ENGINEERING CHANGE NOTICE

1. ECN 0022880
Proj. ECN B-714-93

Block 5: B-714, Grout Vault Pair (218-E-16-102 & 103)(218-E-16-104 & 105)/ER8007

6

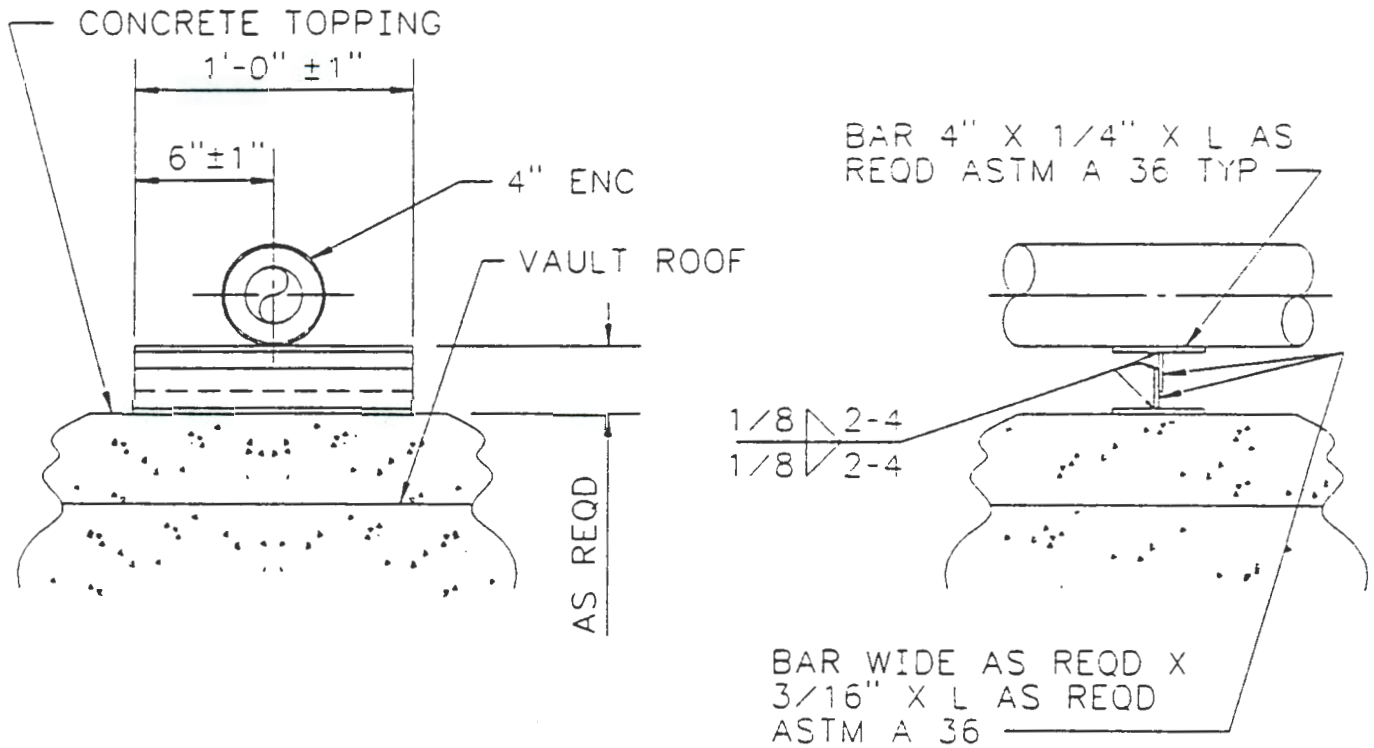
- H-2-77581, Sh 2, Rev 2
Change Note 5 to read "NOT USED".
- H-2-77598, Sh 1, Rev 1
Change Note 3 to read as follows:
 - PIPE SUPPORTS ON VAULT ROOF SHALL BE IN ACCORDANCE WITH DETAIL 6, DWG ~~H-2-78470~~. Per Telecon with K.C.Kenoyer 7-9-91 ^{OP. 7-9-91} H-2-77599.
- H-2-77599, Sh 1, Rev 1
 - DETAIL 6: Replace old detail with new detail as shown on page 4 of this ECN.
 - DETAIL 5: Delete words "& NAIL IN PLACE" and delete weld symbol in its entirety.

A) DETAIL 6: Replace old detail with new detail as shown on page 4 of this ECN.

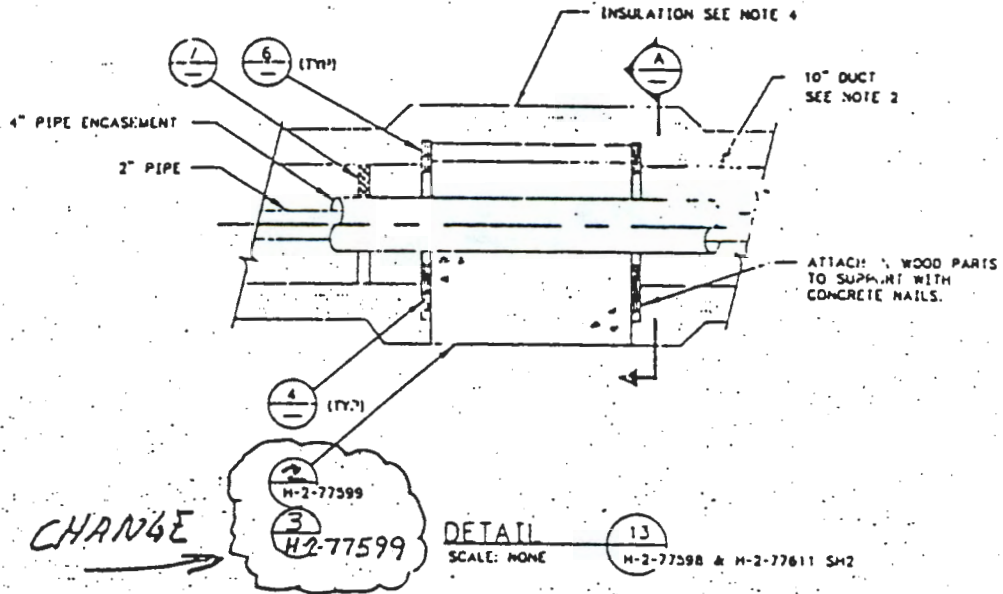
A) DETAIL 13: Modify - see page 5 of this ECN.

DETAIL 13: Modify - see page 5 of this ECN.
